DOCUMENT 00 09 00

ADDENDUM NO. 7

Date: **May 31, 2019**  
Project: **Ltd. Renovations at Police Annex**  
**Contract No. P-18-001**  
3204 Amnicola Highway  
Chattanooga, Tennessee 37406

### 1. Sheet A1.2 – 1<sup>st</sup> Floor Demolition Plan

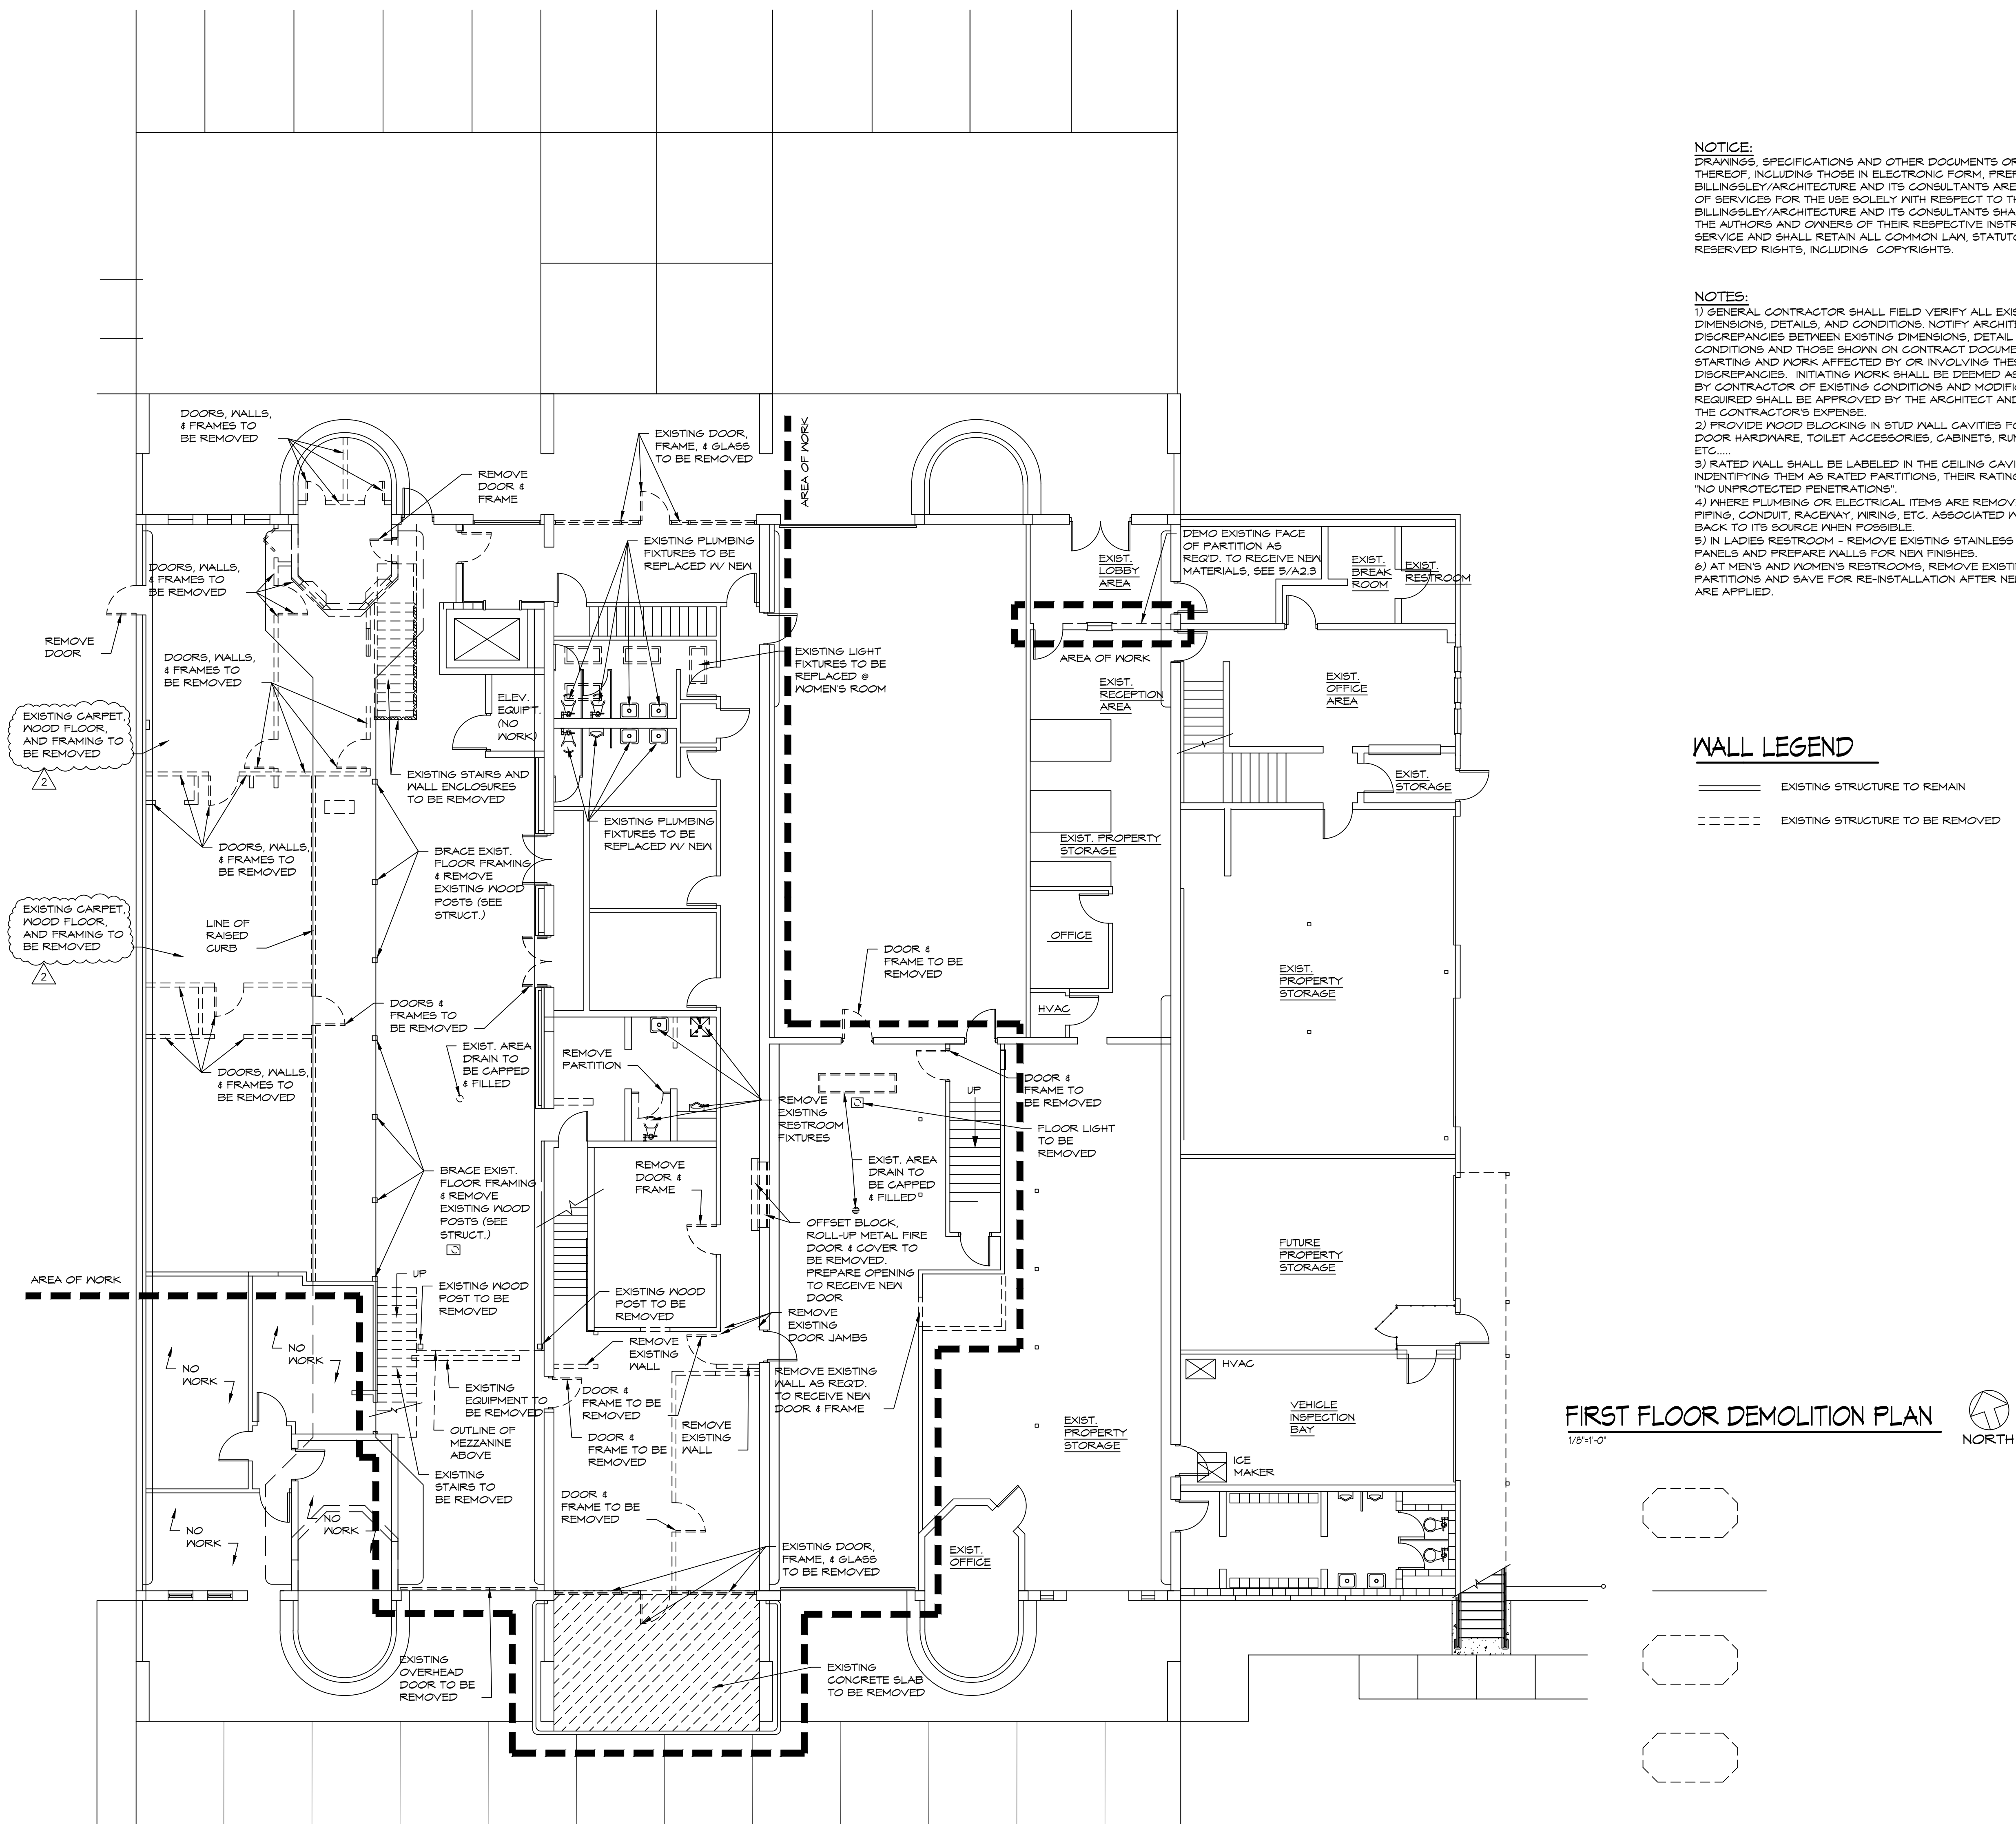
- a. Add new notes at First Floor Demolition Plan.
